ADDENDUM 1 TO ENVIRONMENTAL IMPACT REPORT

Date of Publication of Addendum: October 10, 2024
Date of EIR Certification: September 5, 2019
EIR Case No. **2015-014028ENV**
Project Title: **3333 California Street Mixed-Use Project**
Modified Project Case No.: **2015-014028ENV-02**
Block/Lot: 1032/003
Project Sponsor: Don Bragg, Laurel Heights Partners, LLC
(415) 857-9324
Lead Agency: San Francisco Planning Department
Staff Contact: Debra Dwyer – (628) 652-7576
debra.dwyer@sfgov.org

Figure 3. Proposed Site Access - Approved Project

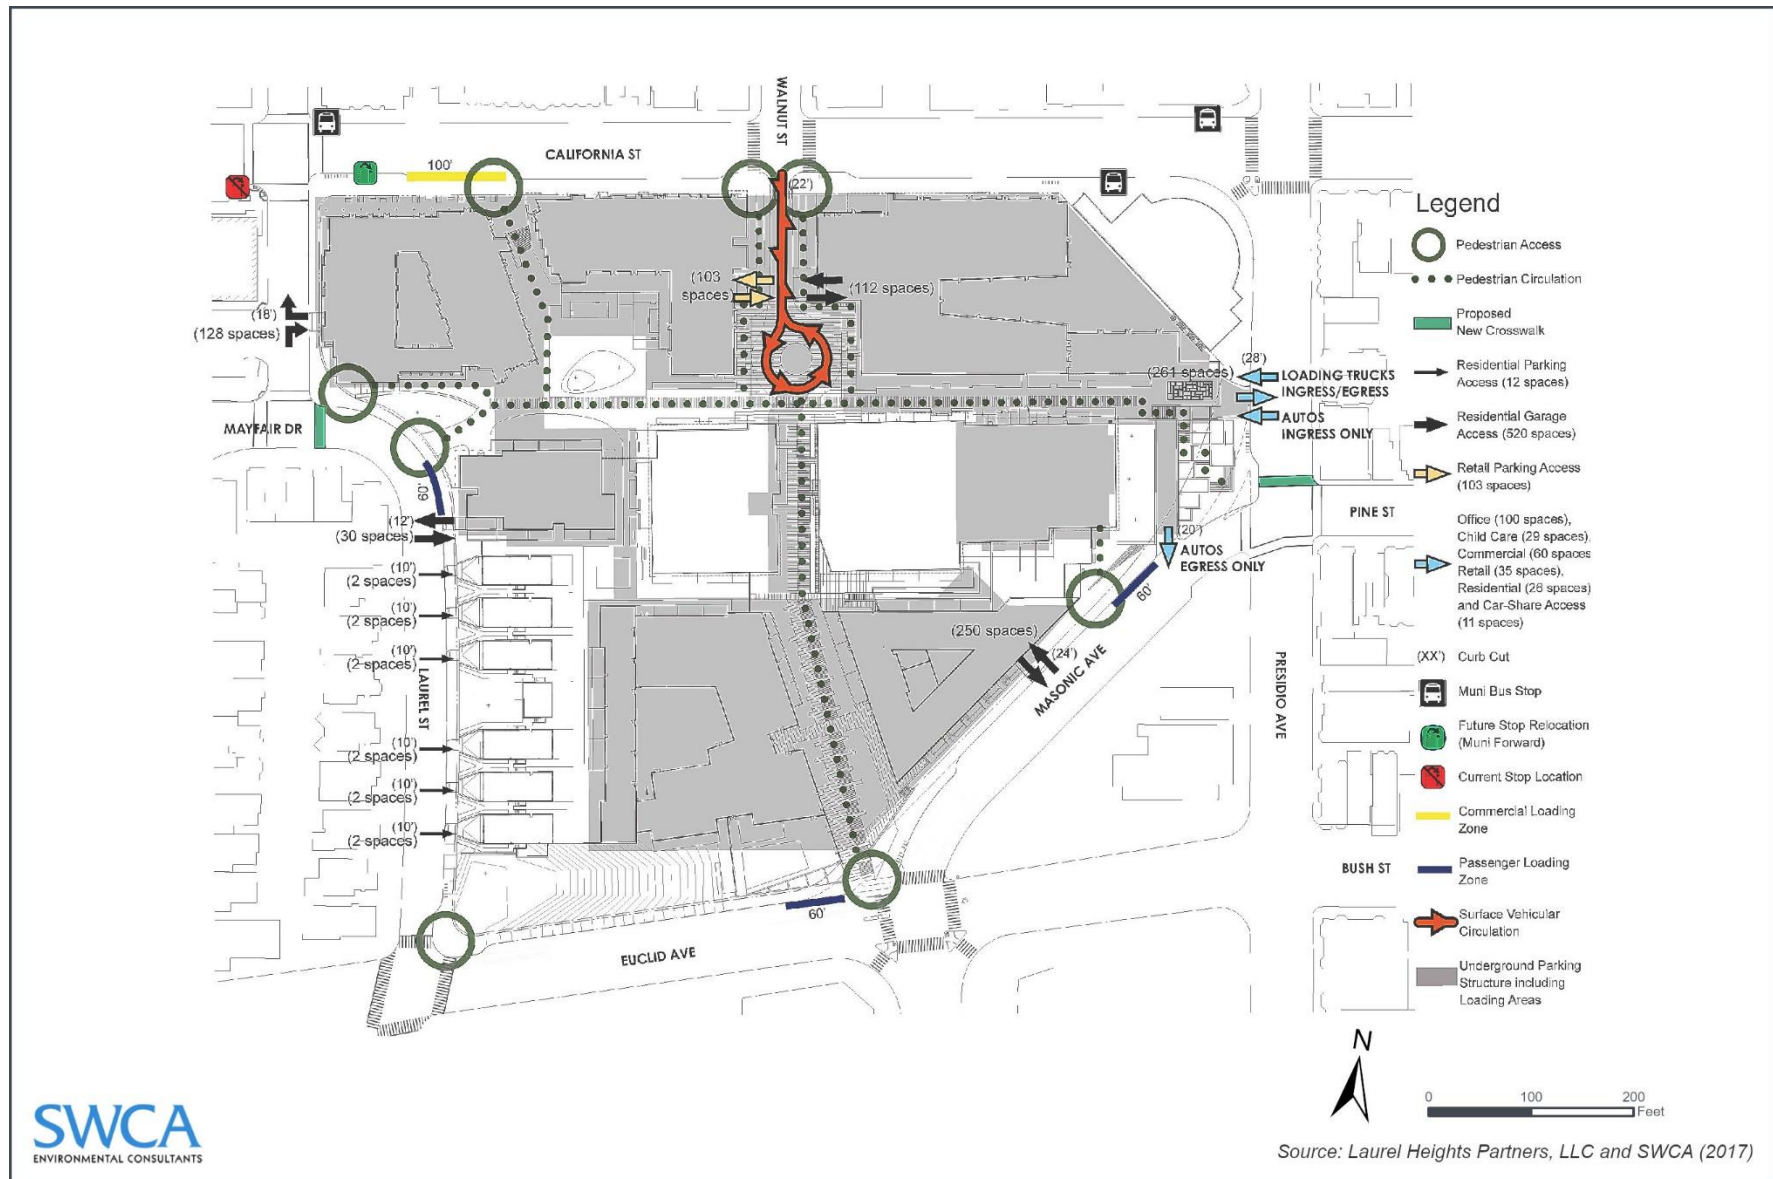
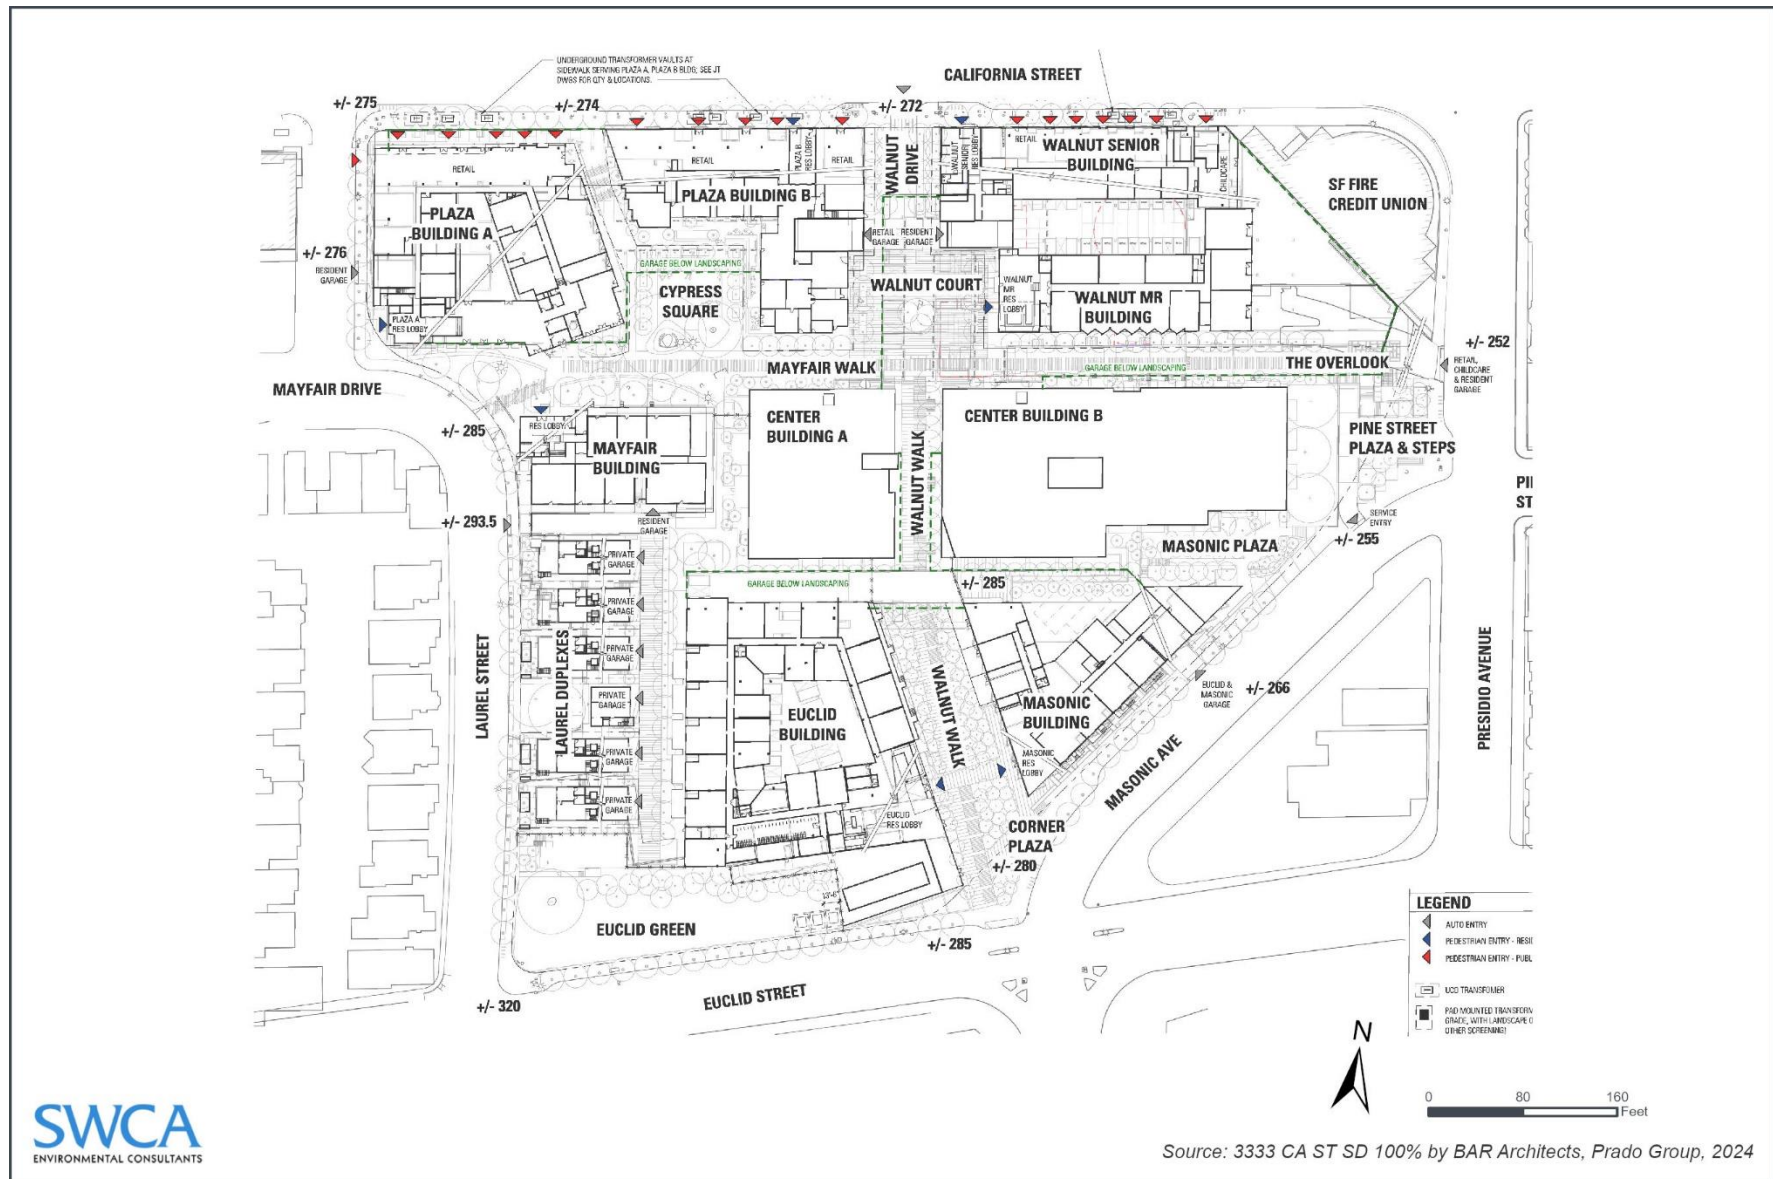
Under the modified project, the proposed off-street parking garage layouts for the California Street, Masonic Avenue, and Laurel Street/Mayfair Drive garages would be slightly different than those assumed for the approved project. Under the modified project on-street commercial and passenger loading zone locations and widths would be essentially the same as the approved project as would the curb cuts and

driveway locations for entry and exit to the off-street garages (see **Figure 3: Proposed Site Access - Approved Project**, p. 13, **Figure 4a: Proposed Site Access - Modified Project**, p. 14, and **Figure 4b: Proposed Site Access - Modified Project**, p. 15).

Figure 5. Preliminary Construction Phasing Diagram - Approved Project

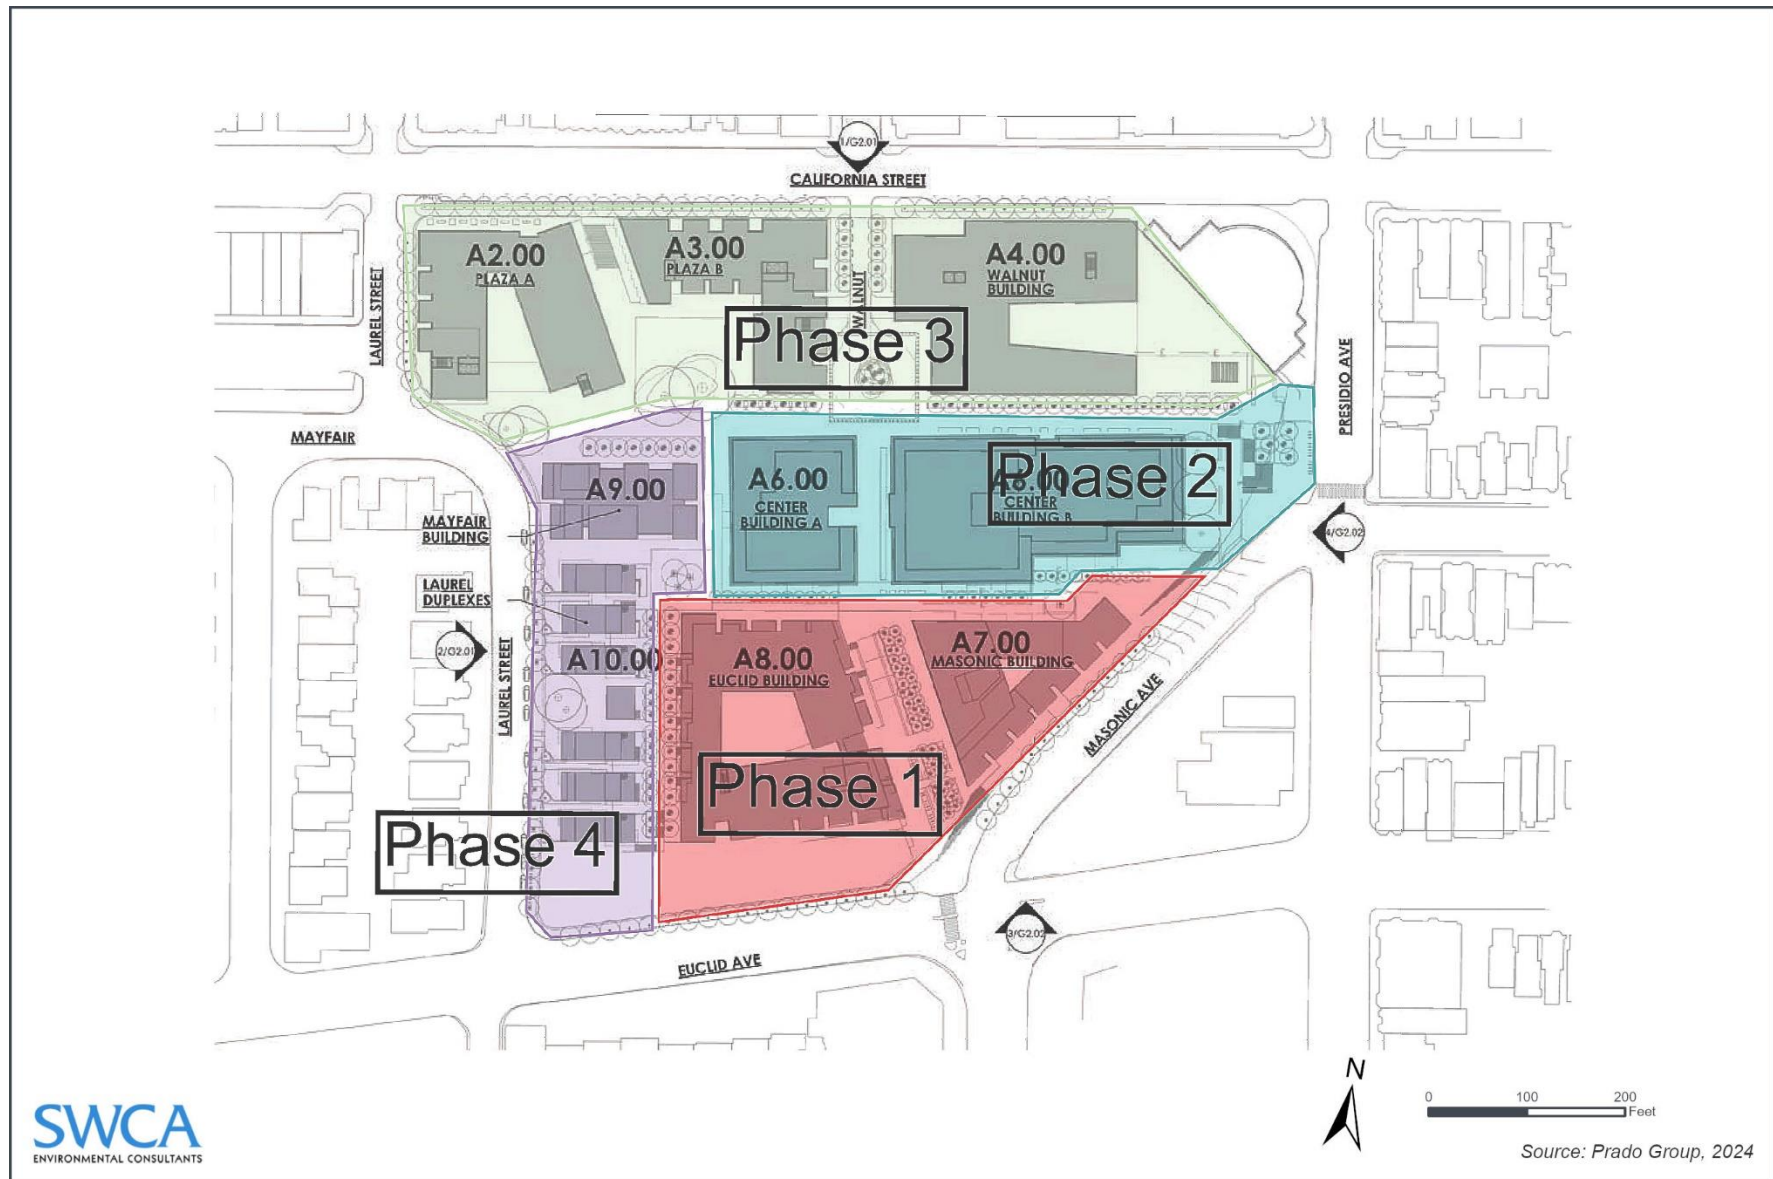
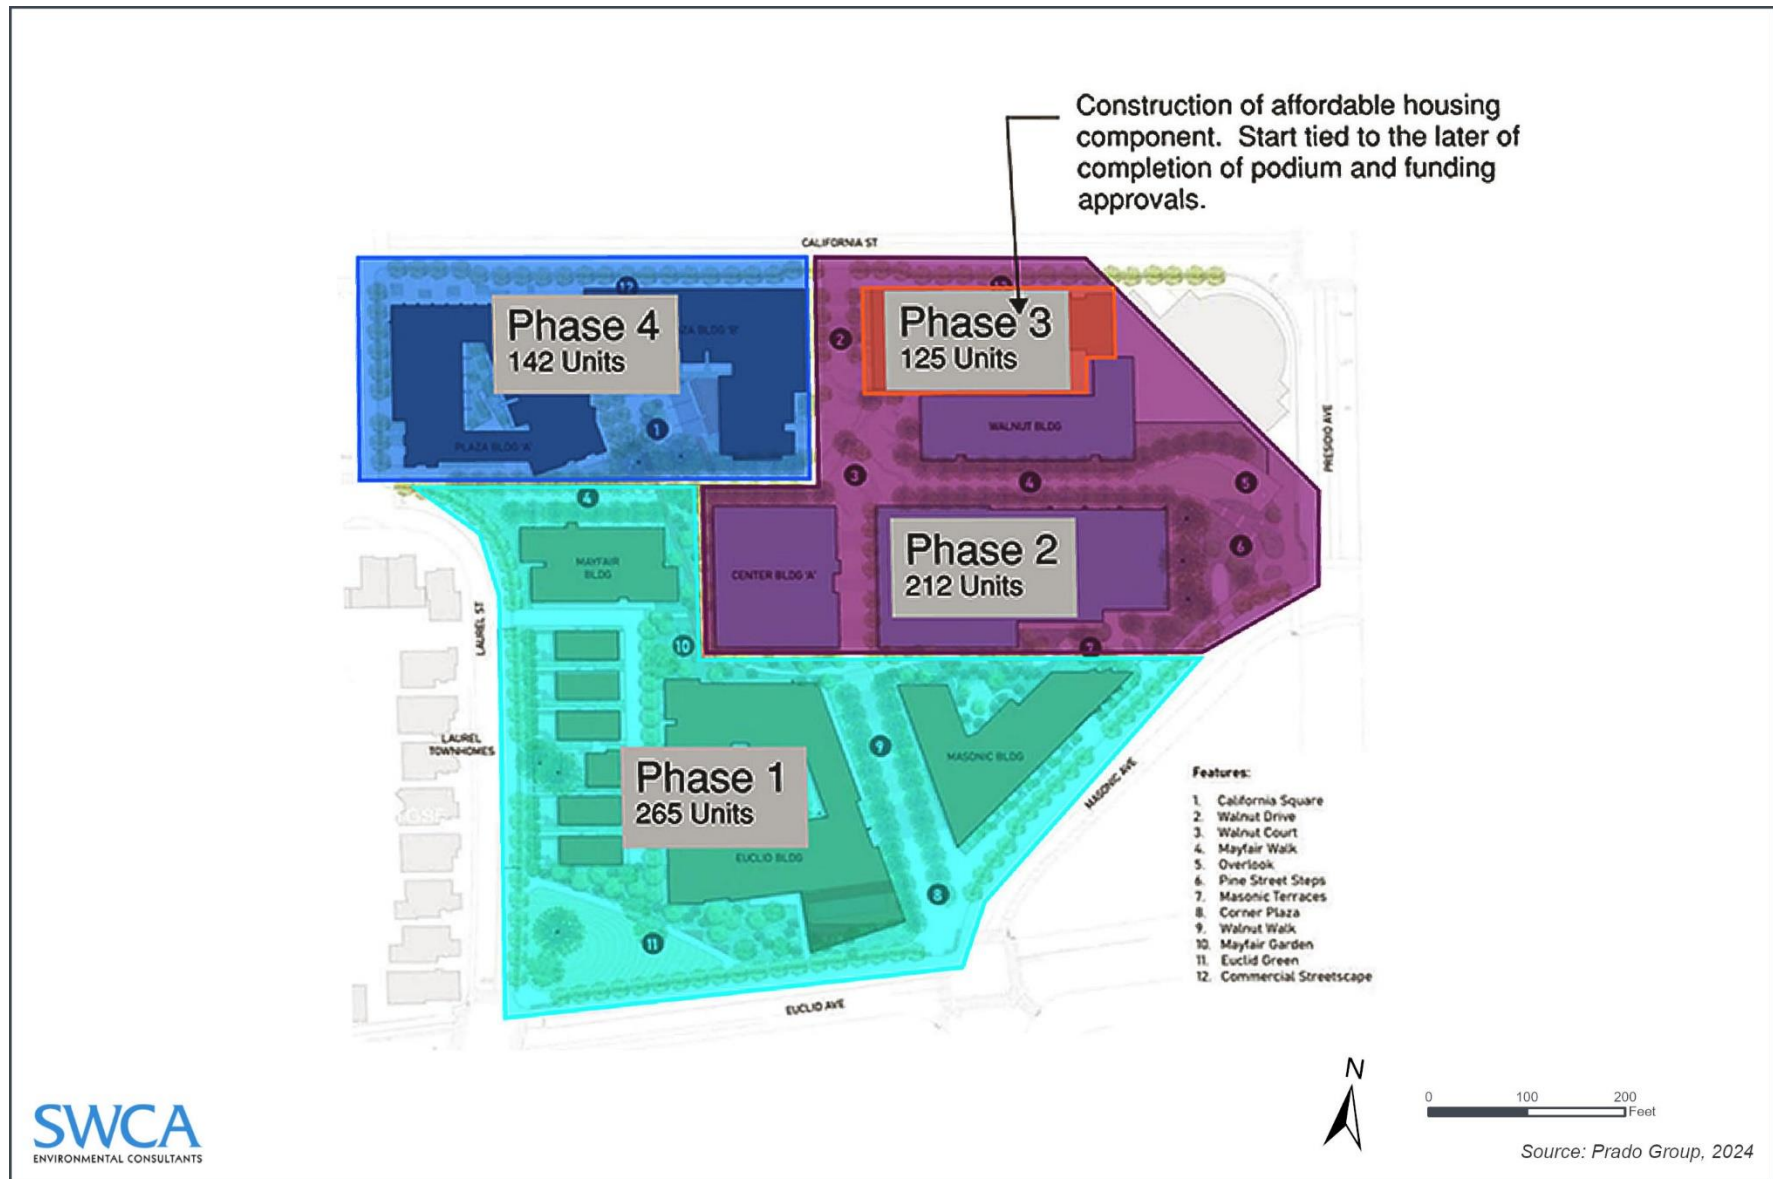
Full-build out under the modified project would be expected in five years, rather than in seven years as described and analyzed in the EIR for the most conservative CEQA analysis. As shown in **Table 3**, p. 9, the preliminary construction schedule under the modified project assumes spring 2025 as the start of construction and spring 2030 as the end of construction. As shown in **Figure 5: Preliminary Construction Phasing Diagram - Approved Project** and **Figure 6: Preliminary Construction Phasing Diagram - Modified Project**, pp. 16 and 17, construction activities for the four development phases would be modified to develop a larger proportion of the residential component of the overall development program more expeditiously (i.e., more housing units earlier). Like the approved project the proposed development program would also be constructed over four overlapping construction phases but with minor modifications. Site redevelopment under the modified project is listed below Mayfair Building and Laurel Duplexes with Phase 1, as modified, rather than Phase 4, as approved; and Walnut Building (the market rate component) with Phase 2, as modified, rather than Phase 3, as approved.

- Phase 1 (Masonic, Euclid, and Mayfair buildings and Laurel Duplexes)
- Phase 2 (Center Building A, Center Building B, and new Walnut Building)
- Phase 3 (Senior Affordable Housing)
- Phase 4 (Plaza A and Plaza B Buildings)

For the modified project, construction would continue to be sequenced over four development phases but would be developed over five years rather than seven years for the approved project (see **Table 3**, **Figure 5**, and **Figure 6**, pp. 9, 16 and 17, respectively). Further changes would include a slight re-ordering of the components of each of the four development phases, i.e. the Laurel Duplexes and Mayfair Building would shift from Phase 4 under approved project to Phase 1 under modified project. There would be limited changes to the site preparation, demolition, and excavation program. Most other important project features such as number and location of emergency diesel generators and equipment associated with heating ventilation air conditioning (HVAC) systems would also be essentially the same although in slightly different locations due to level-by-level and floor-by-floor refinements to the residential, retail, and childcare uses and to off-street parking layouts. The *2024 Updated Phasing Project Air Quality and Noise Analysis Results* are available for review.⁷
